Historic Architectural Review Commission
Staff Report for Item 15

Application Number: C2026-0024

Address: 1301 Whitehead Street

New two-story accessory structure, modifications to main contributing structure's existing hip and flat roofs, and new gable roof over the side entry door.

Proposed Left Elevation showing flat roof modifications and gable cover over entry door.

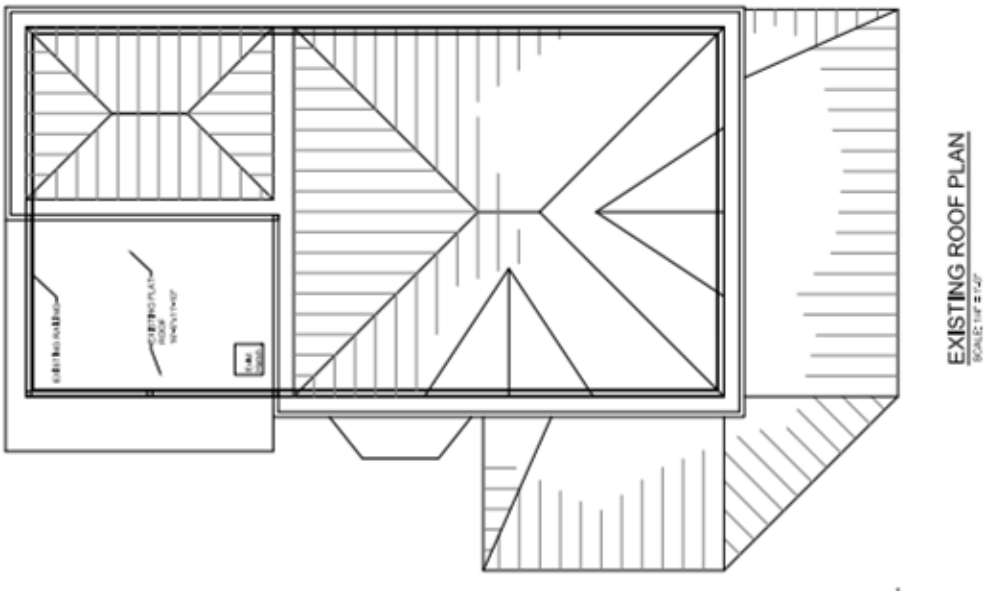
Overall, the proposed plans include some elements that do not comply with the HARC guidelines for contributing structures. The modification of the existing flat roof raise additional concerns, however the addition of railings on the flat roof may be considered with simpler more historically appropriate 2x2 balusters.

Proposed Roof Deck/Attic Plan.

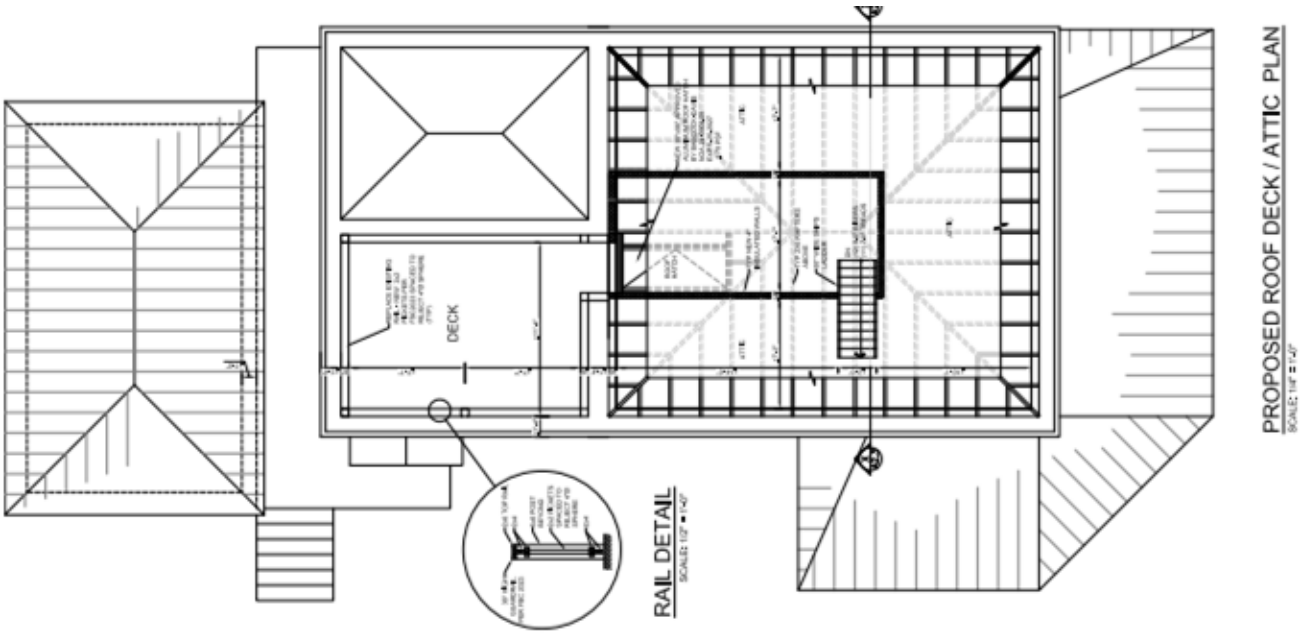
The proposed demolition and alteration of the historic hip roof to create new access by installing an aluminum roof hatch would remove original contributing fabric and alter the historic structure visible from the right of way. This approach is strongly discouraged by the **Guidelines for Additions, Guideline 2,** which requires that the removal of historic materials or alteration of character-defining features be avoided, and **Guideline 29**, which states that destruction of original elements must be minimized. Additionally, **Guideline 30** emphasizes that new work should be attached to non-historic or secondary areas whenever possible. The proposal is also inconsistent with **Guideline 17 of Additions**, which prohibits alteration of roof forms on contributing buildings when visible from the street.

Additionally, the proposal is inconsistent with the **Roofing Guidelines**, specifically Guidelines 4 and 5. **Guideline 4** states that the form and configuration of a roof must not be altered in pitch, design, materials, or shape unless returning the roof to a verifiable historic form. **Guideline 5** states that the public view of the roofline must not be altered by the addition of new features such as scuttles or roof hatches, and that such elements may only be allowed on roof surfaces not visible from the public right-of-way. The proposed aluminum roof hatch alters the existing roof configuration and introduces a new feature that is visible from the public right-of-way, which is not consistent with these guidelines.

Staff recommends that the aluminum roof hatch be relocated to a less visible location that does not front a public street and does not require alteration of the historic roof form. Existing landscaping does not provide adequate screening to reduce its visibility.
